### PLAN CHANGE REQUEST

1. PROJECT: CIMCO WAREHOUSE ADDRESS: 2315 INTER AVE, PUYALLUP, WA 98372
2. OWNER: Rick Velasquez EMAIL: rick@cimcopnw.com
3. DESIGN ENGINEER: Grant J. Middleton, PE EMAIL: gmiddleton@rrlarson.com
4. CONTRACTOR: WESTMARK CONSTRUCTION INC EMAIL: \_\_\_\_\_

PRCCP20230336  
CIMCO WAREHOUSE  
PCR001

ENLARGED VIEW OF WATER MAIN EXTENSION  
PLAN VIEW  
HORIZONTAL SCALE: 1"=20'

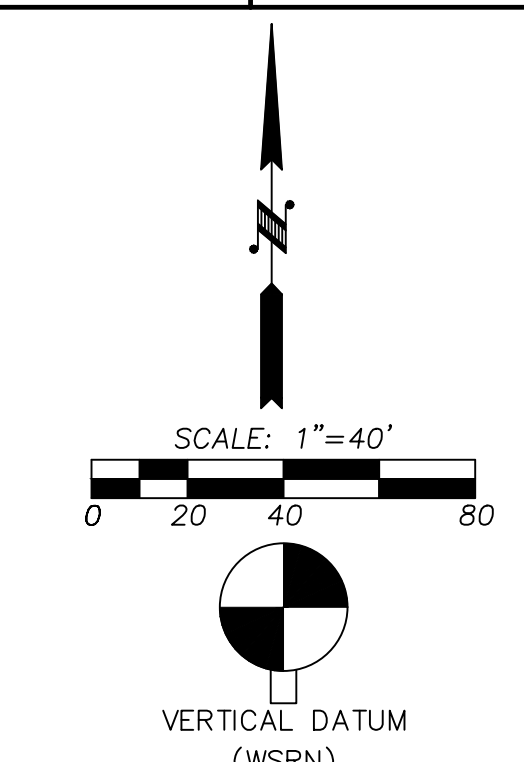
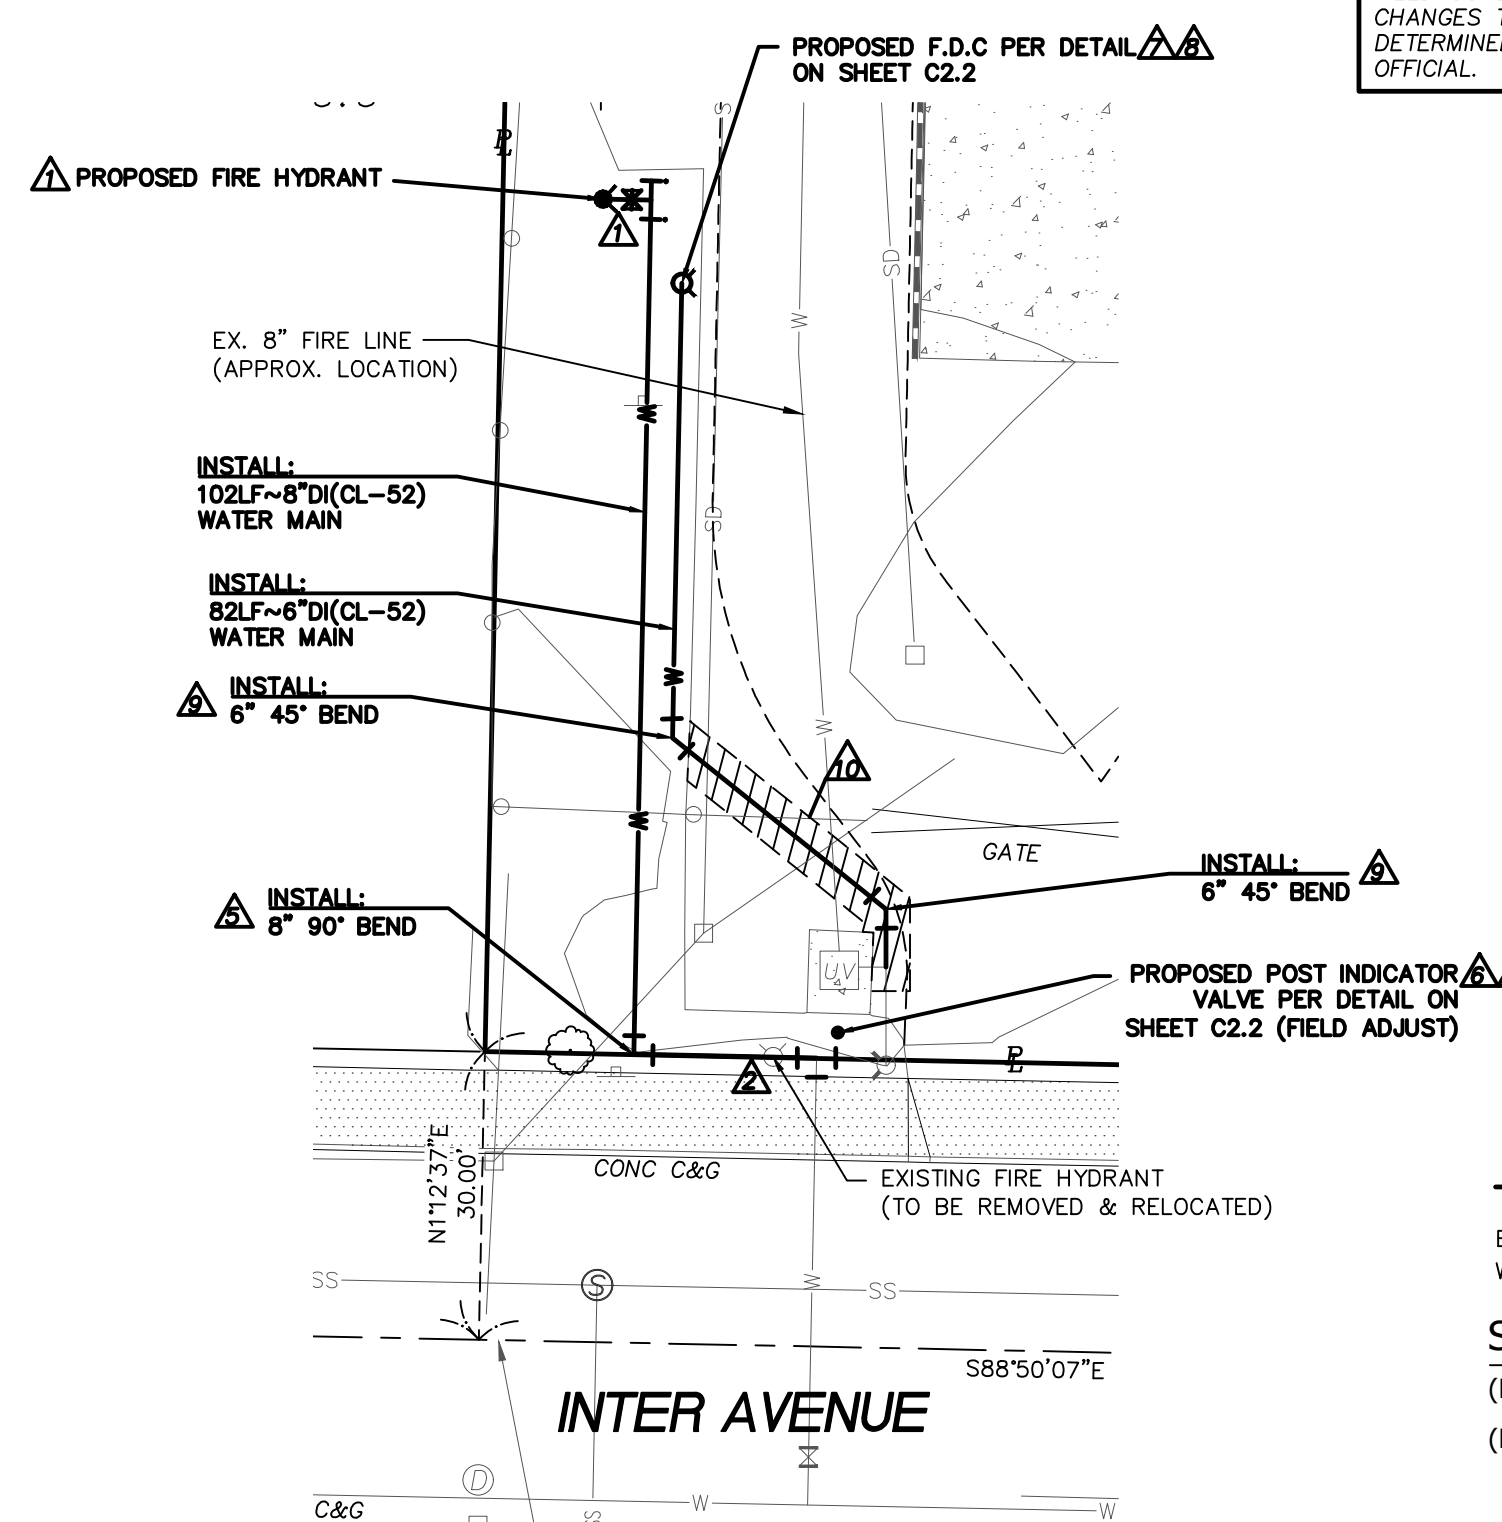
8" water main extension from the existing water main onsite servicing existing building to be extended north to service the proposed building and fire sprinkler requirements.  
This water main/ fire line extension has been triggered due to the anticipated material storage height in the proposed building.

- CONTRACTOR TO REMOVE EXISTING 6" 90° BEND AND INSTALL 6" TEE W/ 8" X 6" REDUCER TO ALLOW EXTENSION OF EXISTING 8" FIRE LINE TO THE NORTH TO SERVICE PROPOSED BUILDING PER CITY OF PUYALLUP REQUIREMENTS.

- SITE CONTRACTOR TO ENSURE FIRE LINE UNDERGROUND PIPING AVOIDS BUILDING FOOTING AT NORTHWEST CORNER OF BUILDING PRIOR TO ENTERING THE BUILDING. FIELD ADJUST FIRE LINE UNDERGROUND PIPE ROUTING, AS NECESSARY.

CONDITION:  
\*CDF backfill required when undermining existing foundations
